Cabin John Village, Preliminary Plan No. 120180120

Cabin John Village, Preliminary Plan No. 120180120:

Staff Recommendation: Approval with conditions

SECTION 1 – EXECUTIVE SUMMARY

Figure 12 - Protected Trees to be affected but retained on the north side of the Property

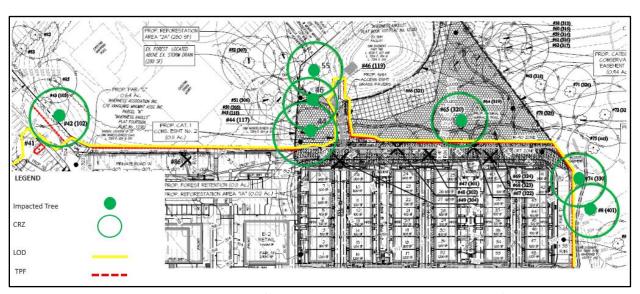
<u>Variance Request</u> – The Applicant submitted a variance request in a letter dated September 7, 2018, for the impacts to trees (Attachment 13). The Applicant wishes to obtain a variance to impact, but not remove, ten (10) Protected Trees that are considered high priority for retention under Section 22A-12(b)(3) of the County Forest Conservation Law. Details of the Protected Trees to be affected but retained are listed in Table 10 and shown graphically in Figure 12 & 13.

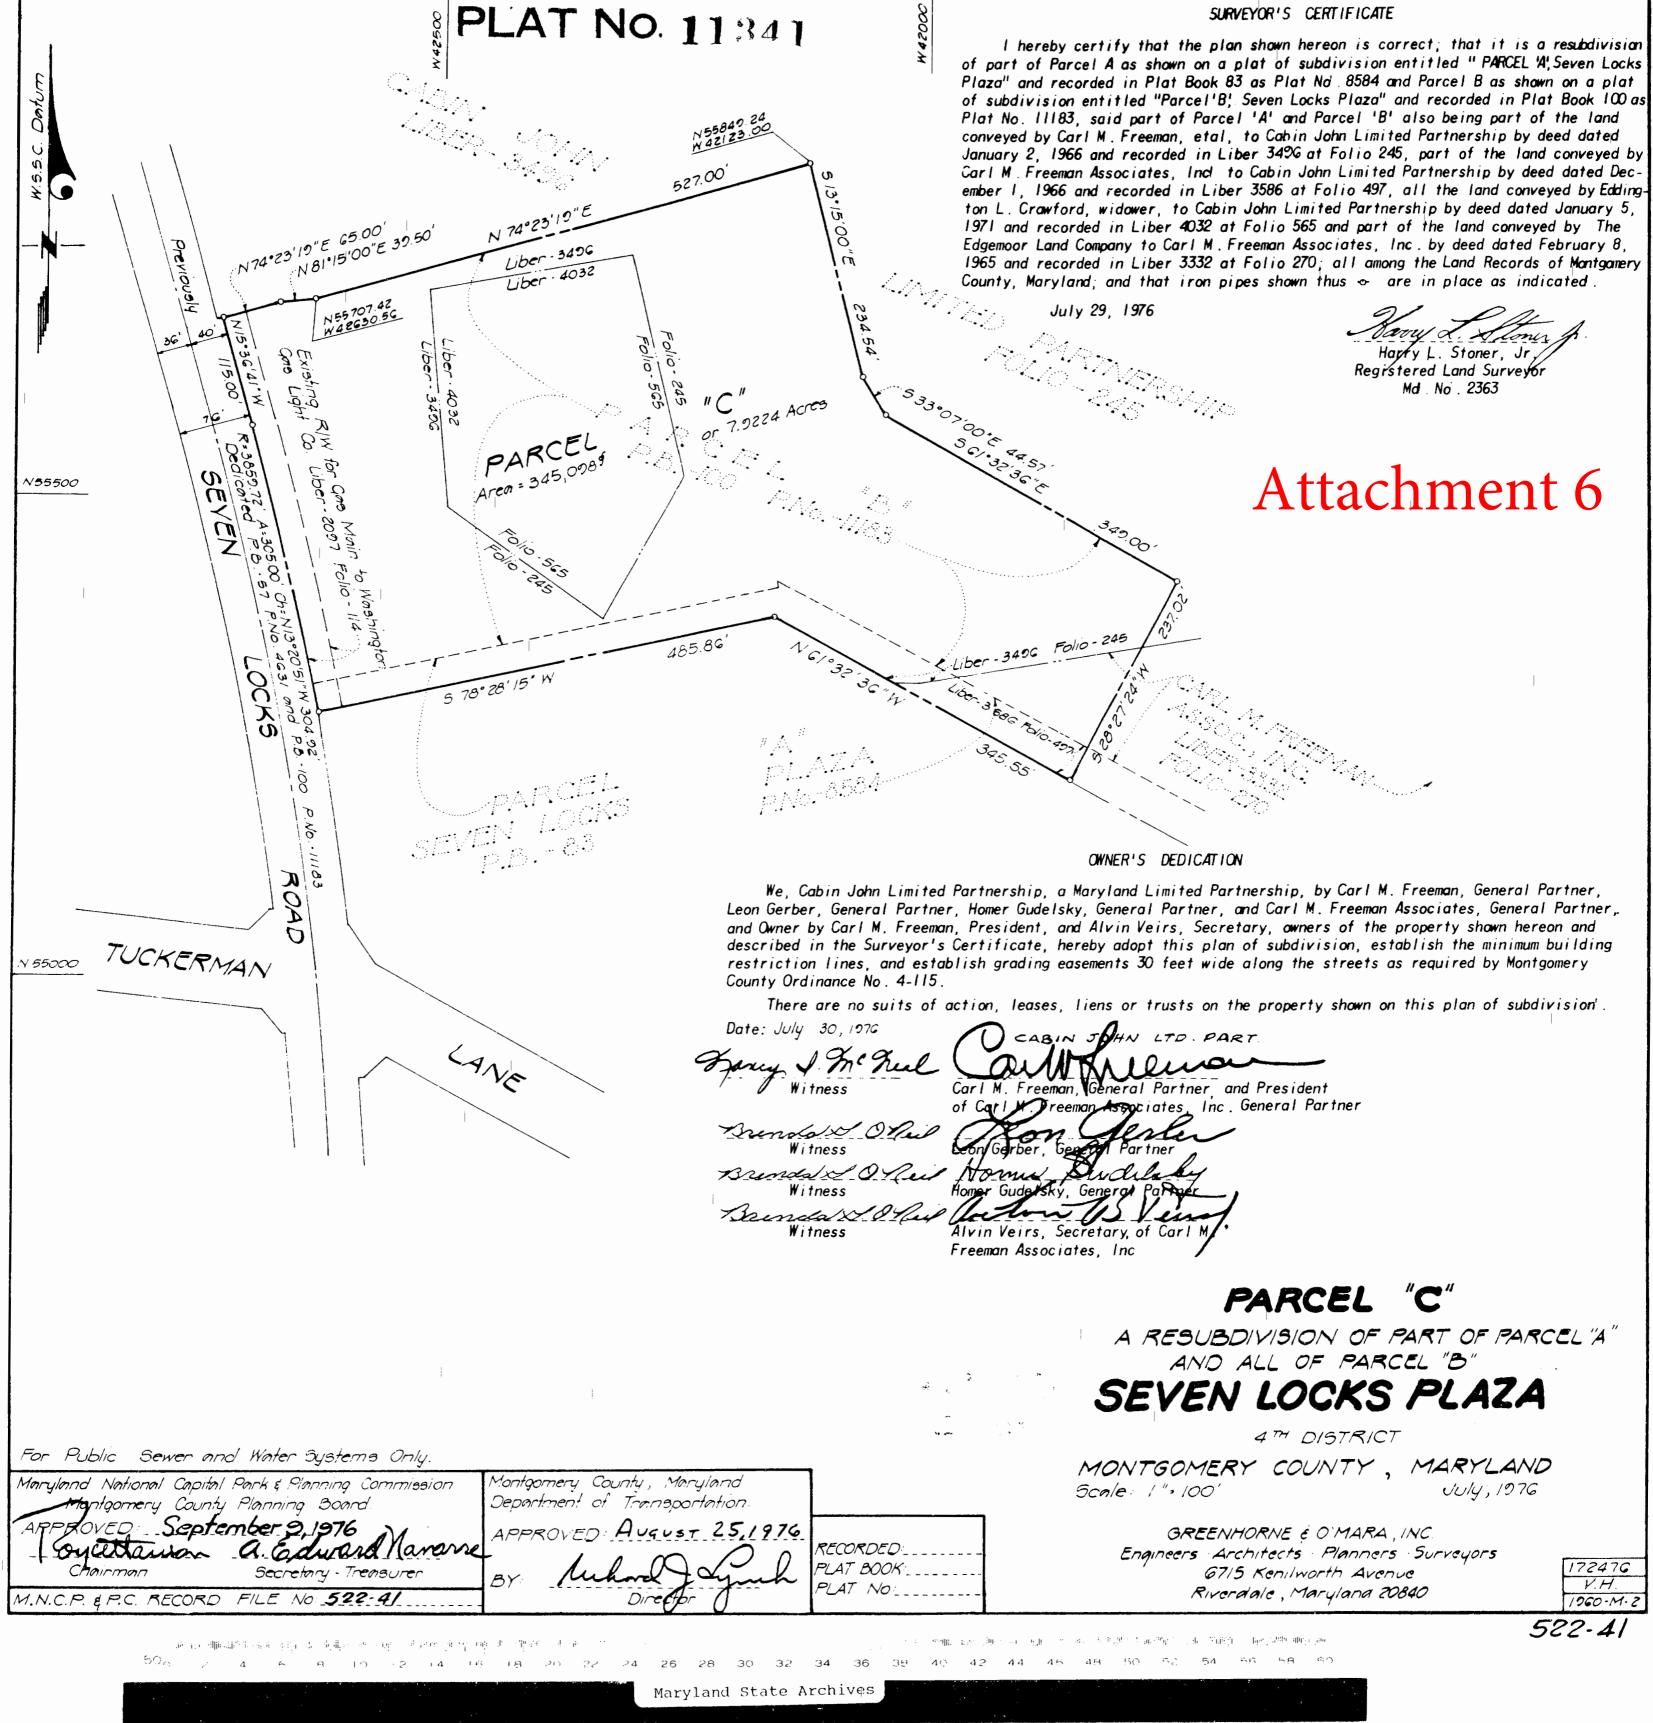
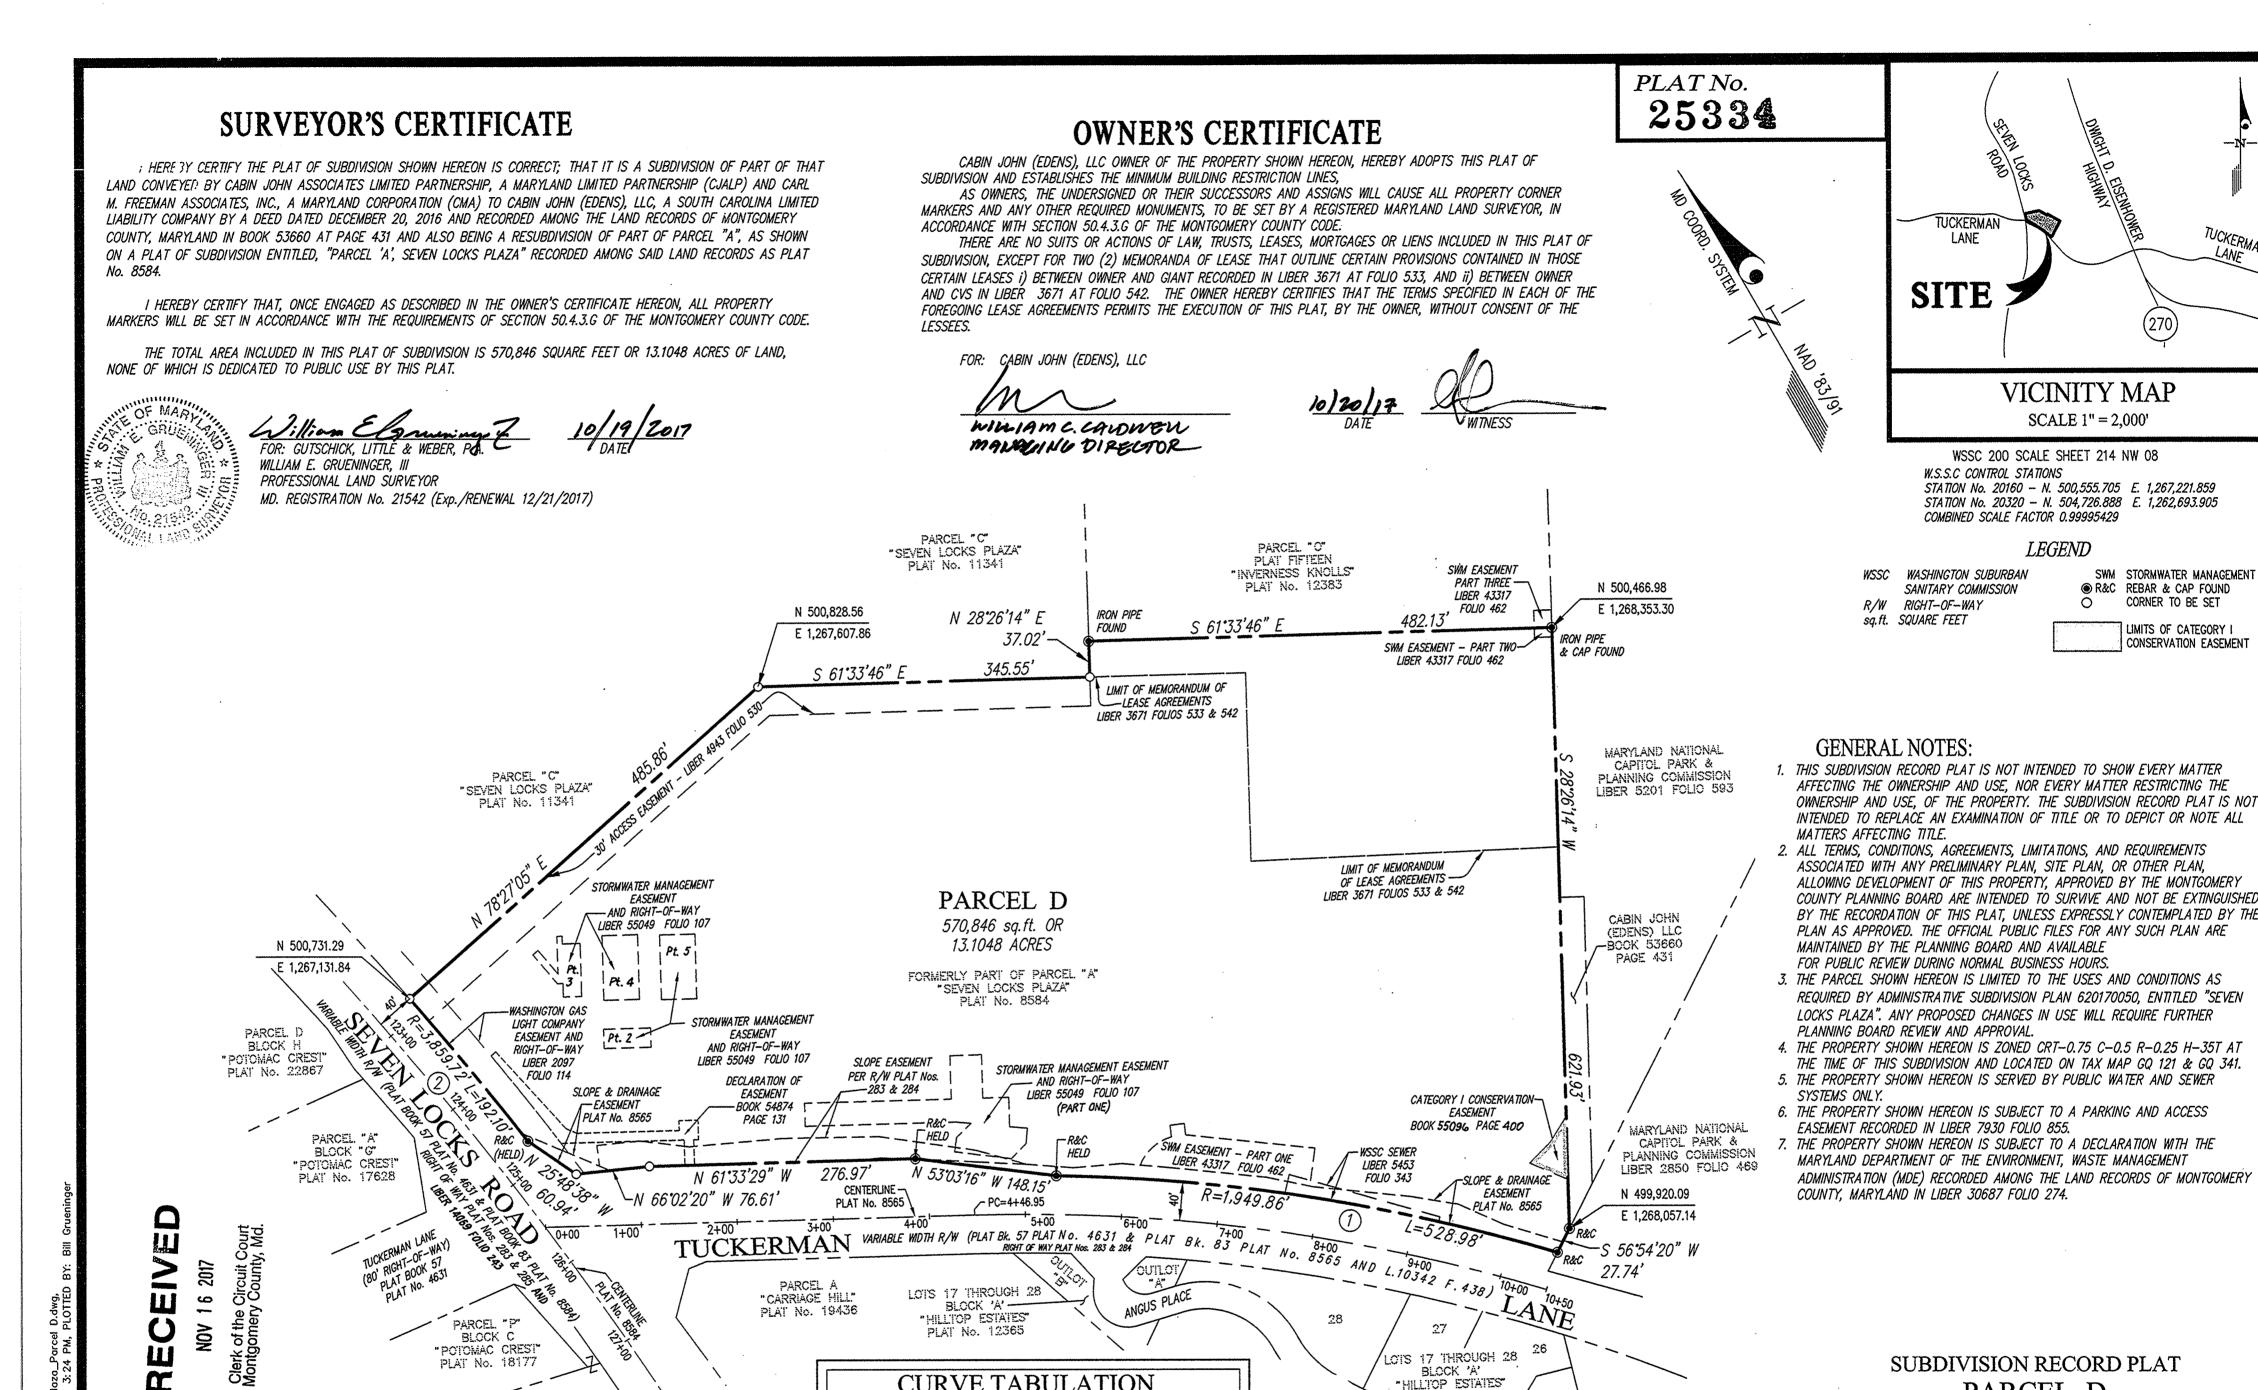
- a. Applicant must remove reference to 'Alley E' on sheets 003 and 004.
- b. Applicant must note on sheet 004 which pavement section applies to which cross section.
